GENERAL APPLICATION

Location Address: 1818 Madison Street, Hollywood, FL 33020

SUBJECT: Site Plan Review for a mixed-use development including 12 residential units and retail space (Madison Apartments).

SUBJECT: Site Plan Review for a residential development including 15 residential units
(Madison Apartments).

PAVING, GRADING
AND DRAINAGE
PLAN

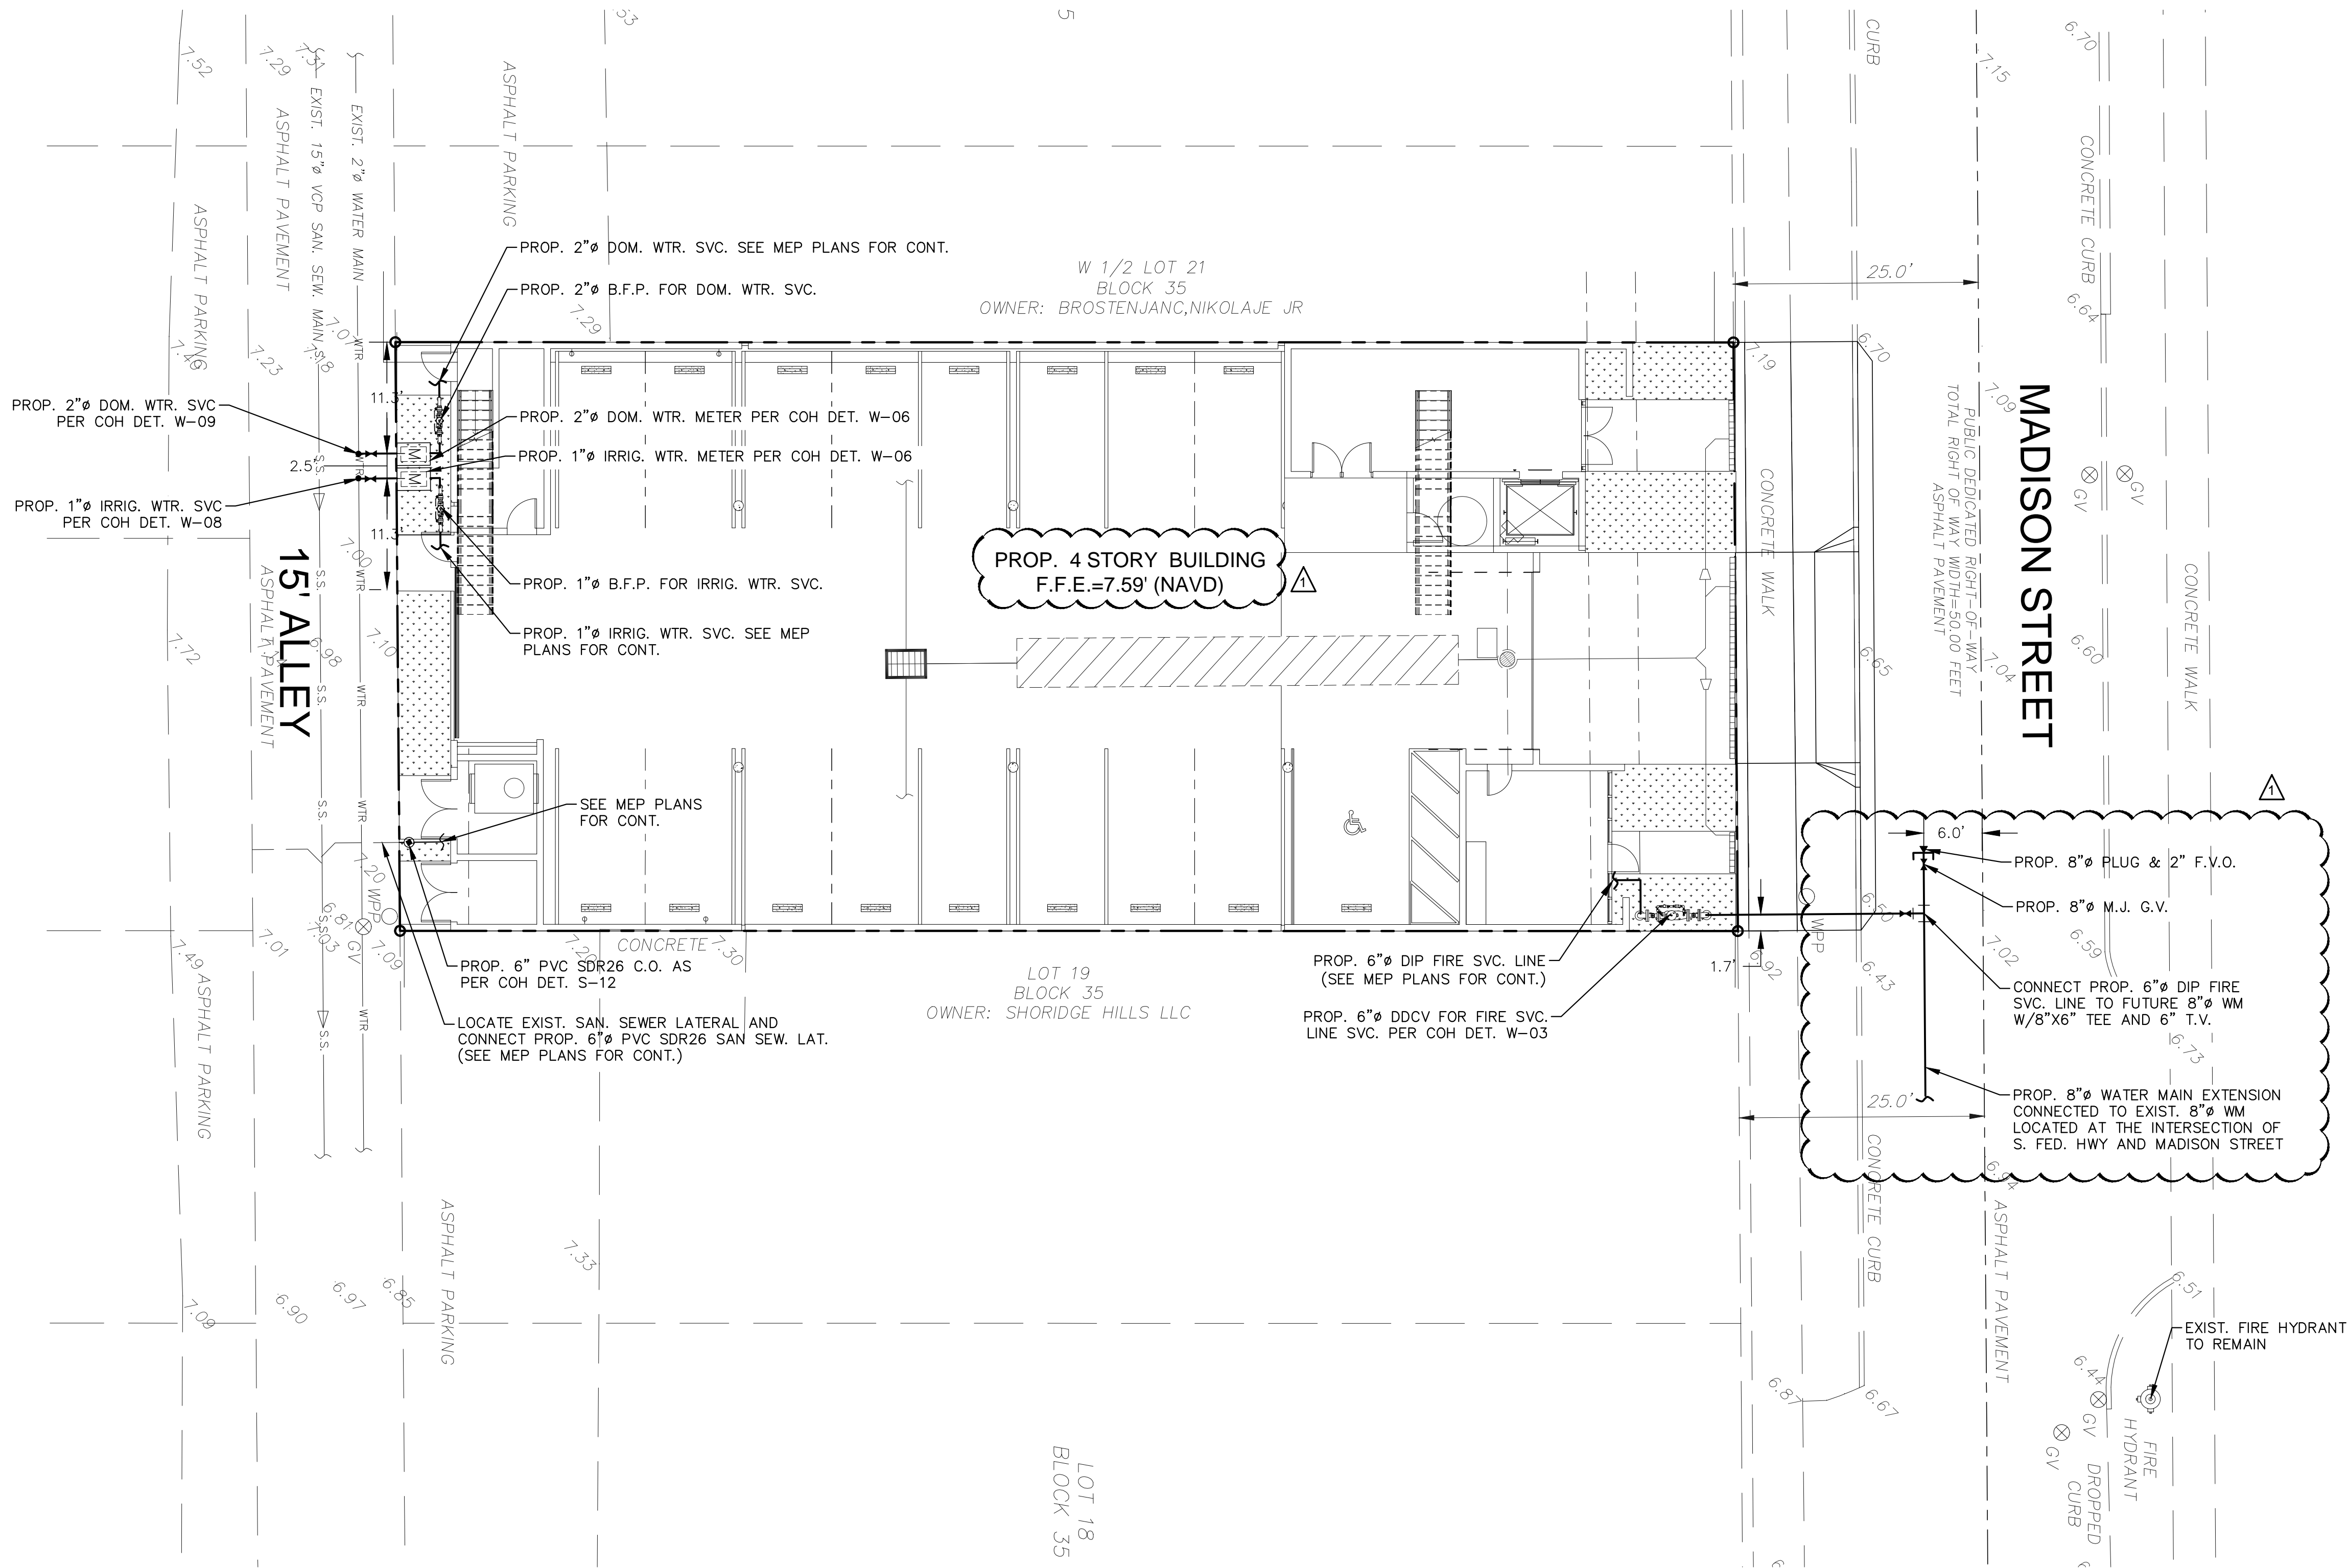
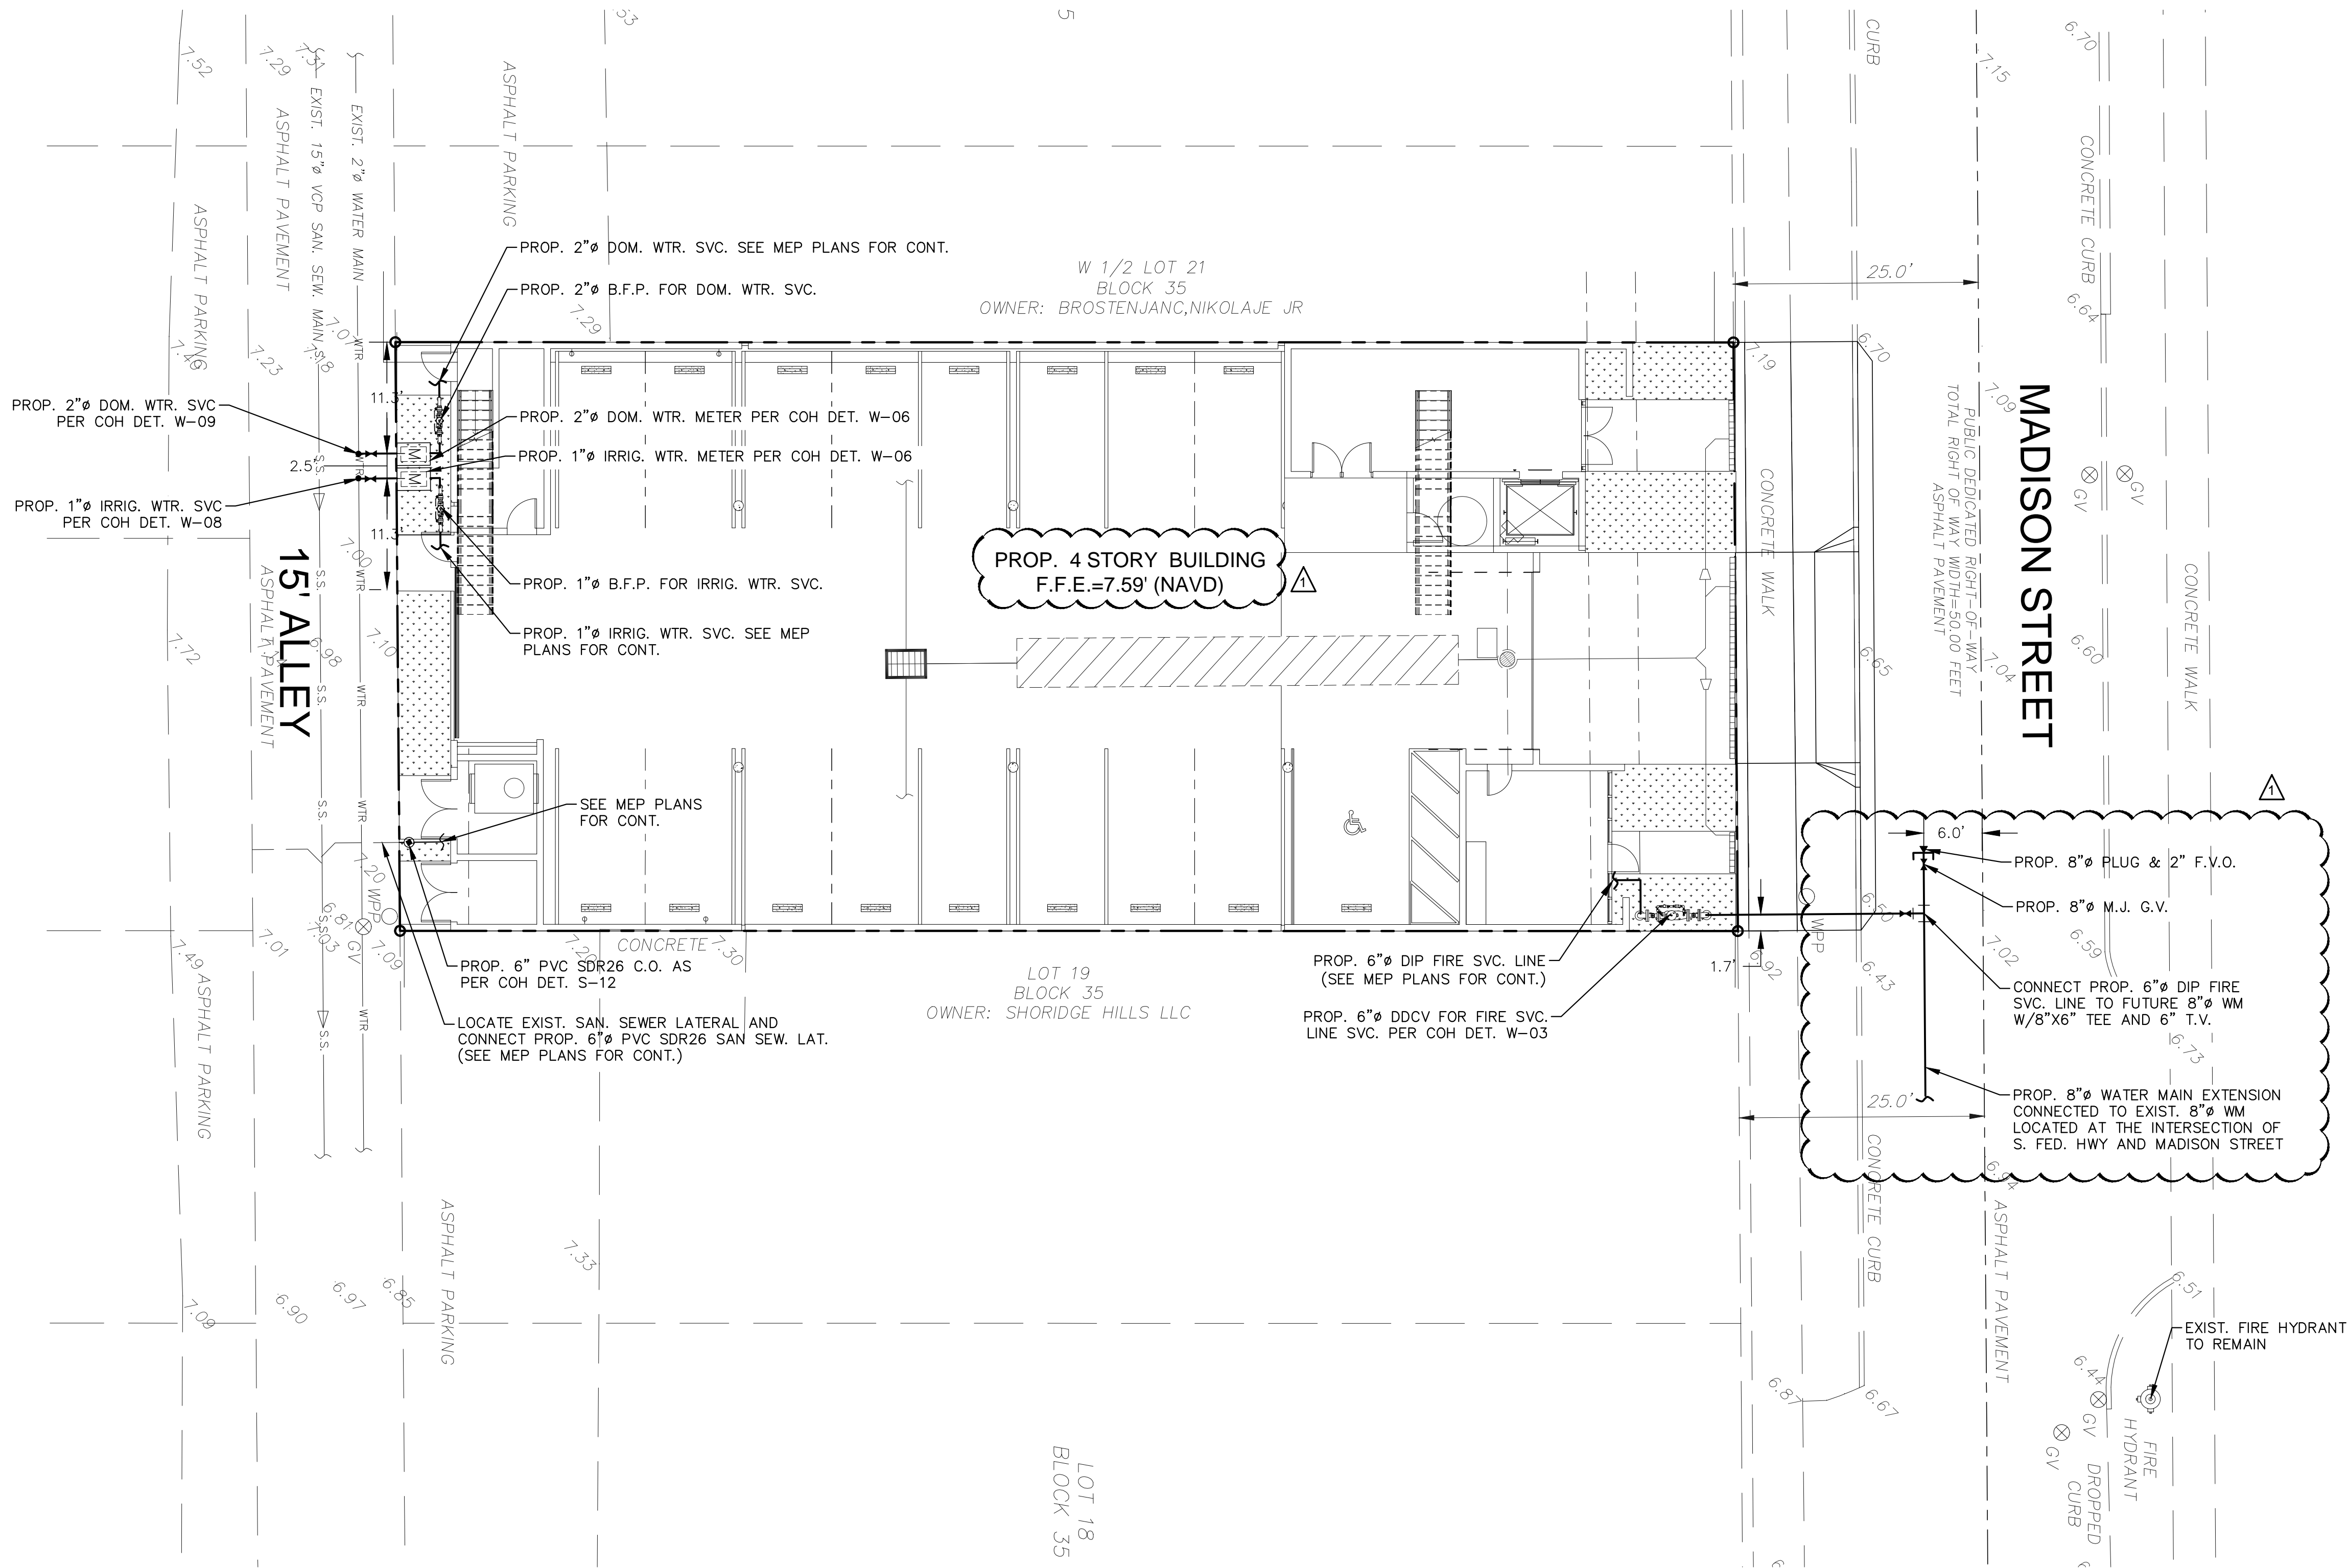
9. On civil plans, indicate area of pavement restoration on plans. Pavement resurfacing covering full alley width along the width of the property's lot will be required. Include pavement restoration detail.

2. Pg. C300, it's unclear if the fire main is being proposed to run under the building as there is no fire main line from the DDDV side of drawing to the city main. If so, this is not a good practice due to potential maintenance issues, and difficulty visualizing for inspection purposes. Please clarify.

4. As a result of the hydrant flow test, show any existing and new fire hydrants on civil drawings. A copy of the completed hydrant flow test and engineer's calculations are required at the next submittal.

5. Provide a note on civil drawings that underground fire main work will need to be completed by a contractor holding a Class I, II, or V license per FS 633.102.

- **Fire hydrants are now shown on Survey and Civil Plans**
- **Civil Plans were updated with the required info.**

1 LANDSCAPE PLAN
1/8" = 1'-0"

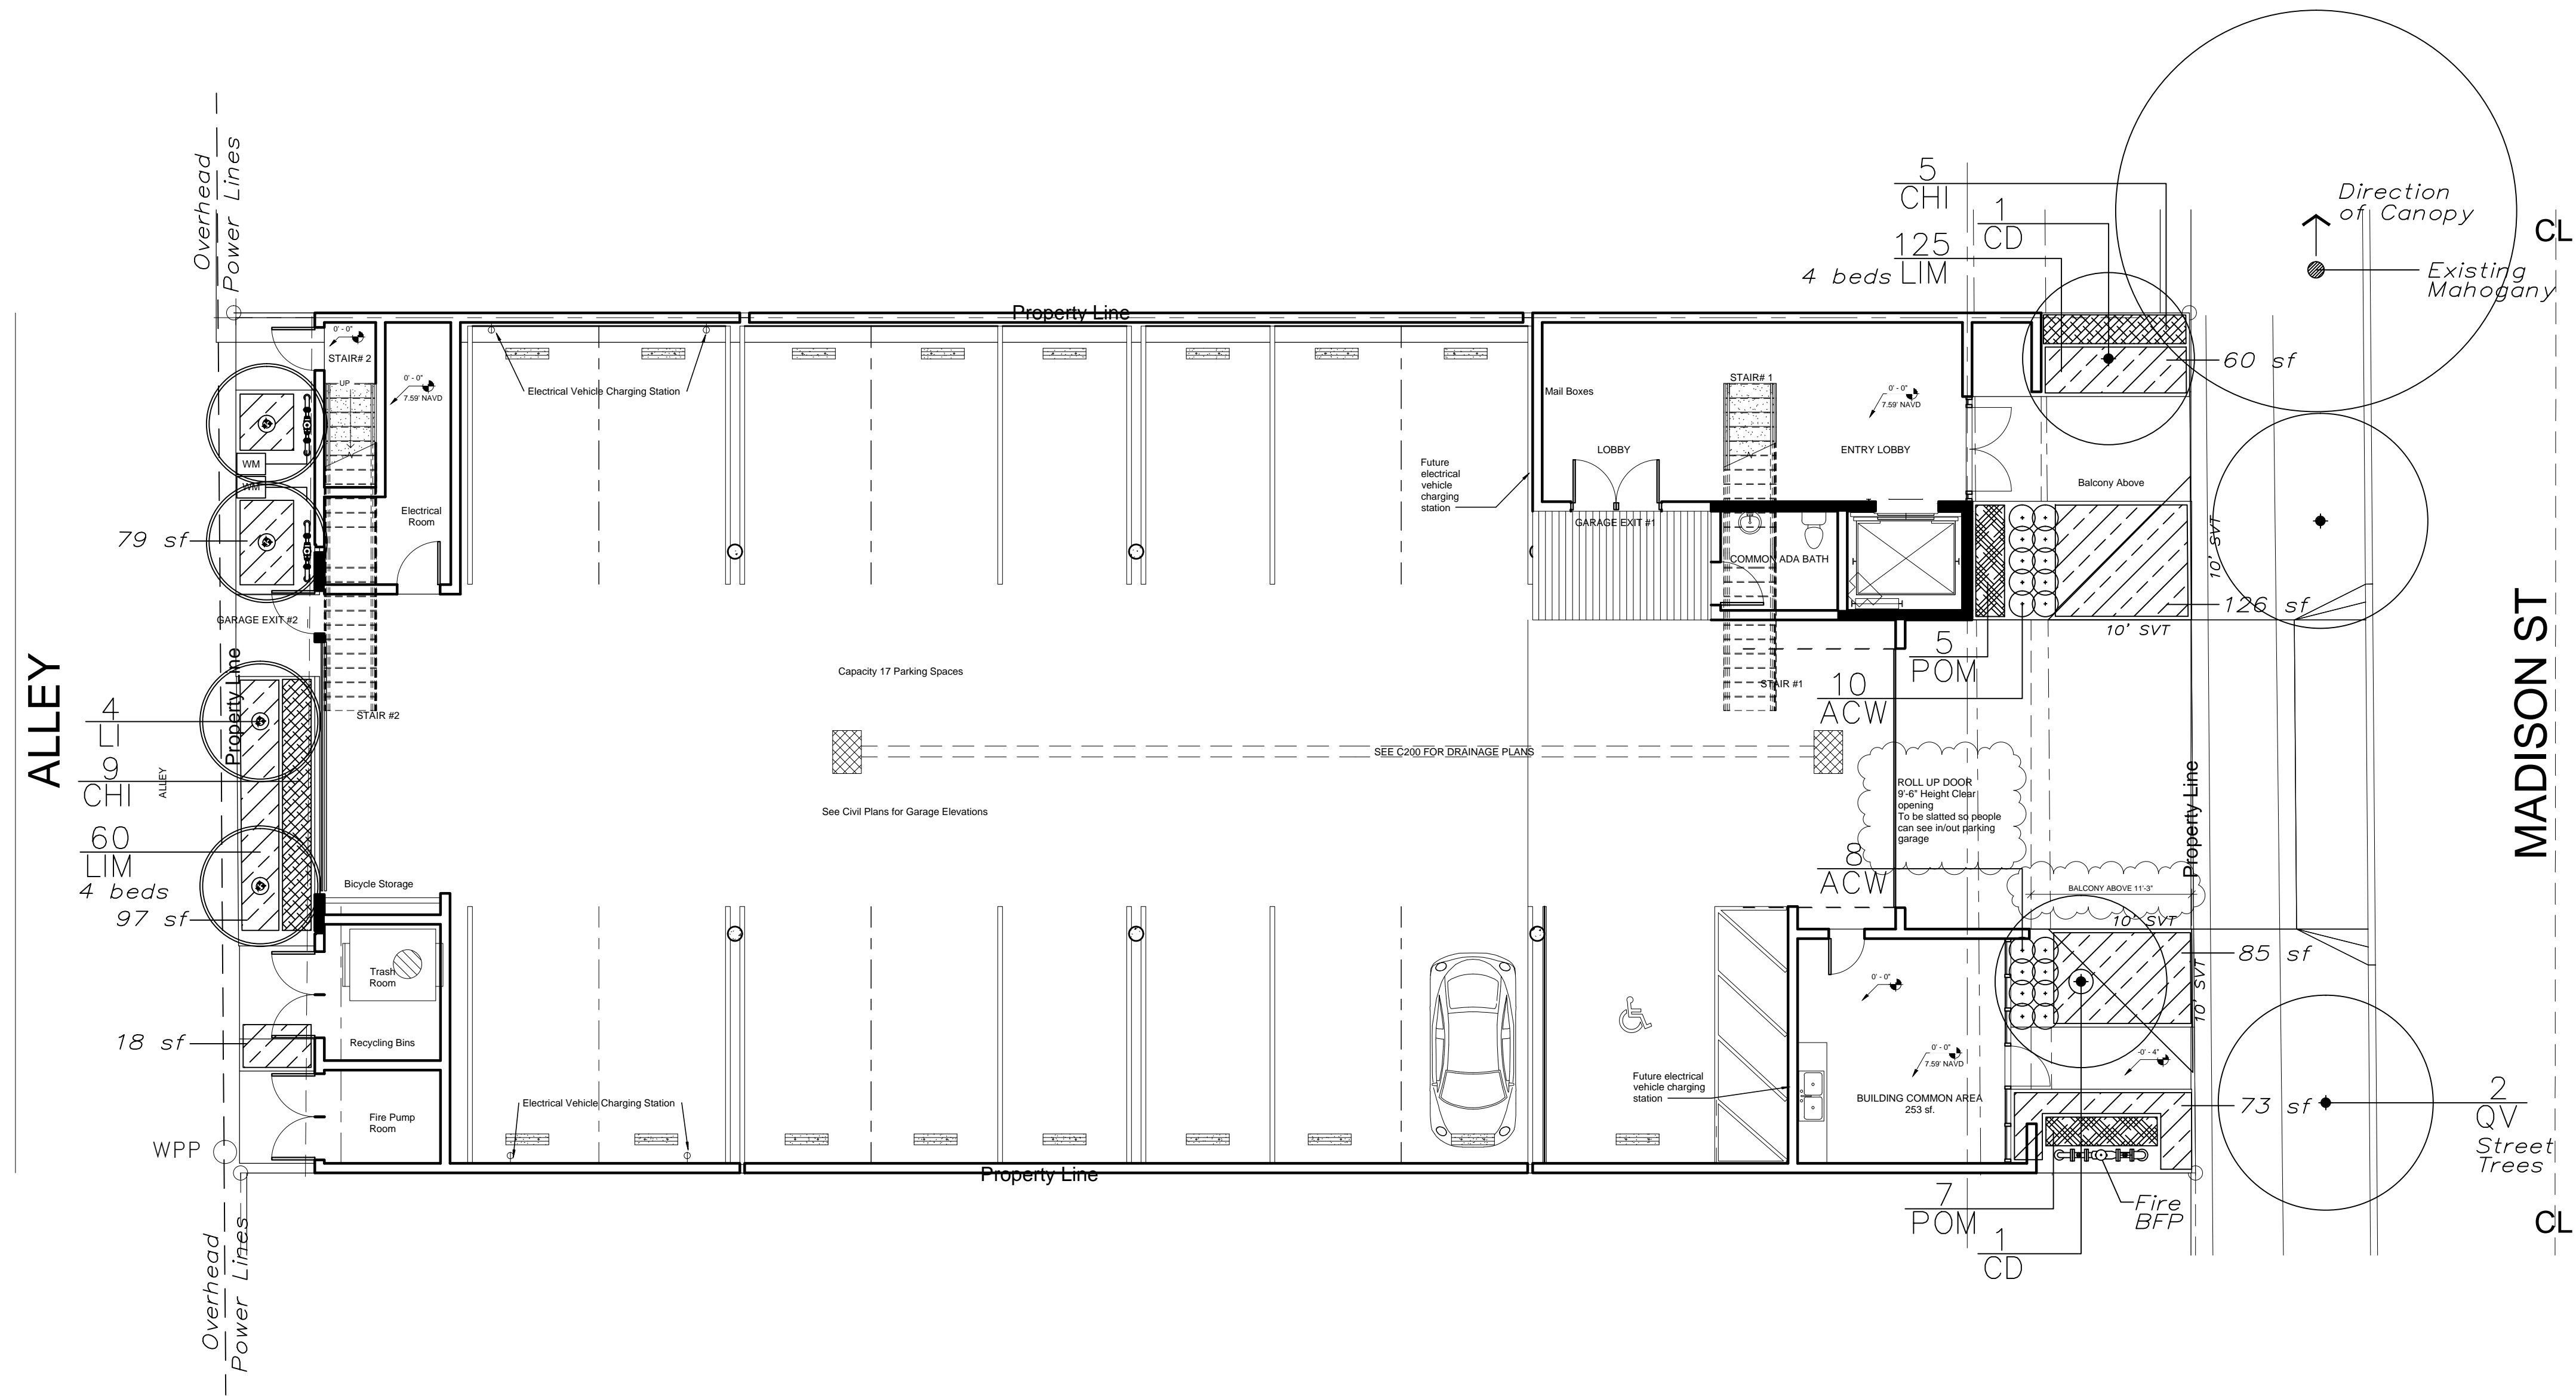
3. Increase landscape trees to provide clear tree mitigation and list on plant material list on landscape plan LA1.0 in separate from the code required trees.

6. Provide note as part of General notes on LA1.0 that states that all plant material to be planted on site will be maintained in a condition that meets or exceeds Florida Grade #1 and has 1 year replacement warranty period.

R: See updated Landscape Plans.

R: See updated Landscape Plans.
